StrongArm M30/M50 Enclosure Door Weather Stripping

SUBJECT: Weather Stripping for Enclosure Doors (ECO 10571)

Fig-1: M30/M50 Weather Stripping Location/Orientation

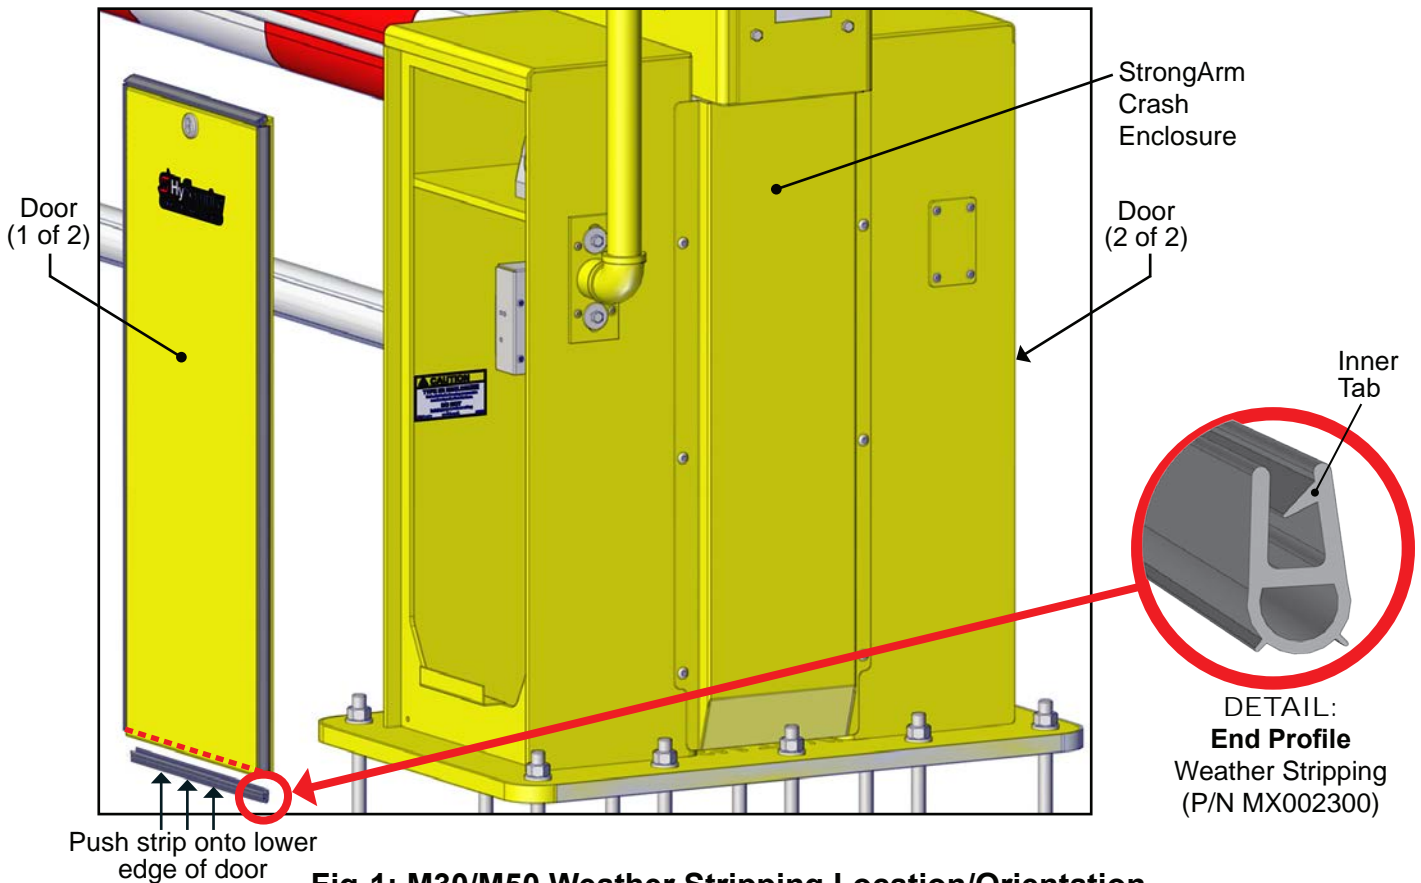
ISSUE DESCRIPTION: In colder climates, snow has been found to be blown into the enclosures.

RESOLUTION: New units will have the section of weather stripping added in production. Current units in colder climates may have two strips (per Kit P/N MX5430) sent to the end-user on request to install onto the enclosure doors.

1. Unlock and remove door (1 of 2) from enclosure (Fig-1).
2. Push rubber weather stripping section over the bottom edge of door (Fig-1), ensuring that the side with the inner tab facing toward the interior (see **DETAIL: End Profile** for reference).
3. Replace door and lock.
4. Repeat Steps 1-3 on other door (2 of 2).
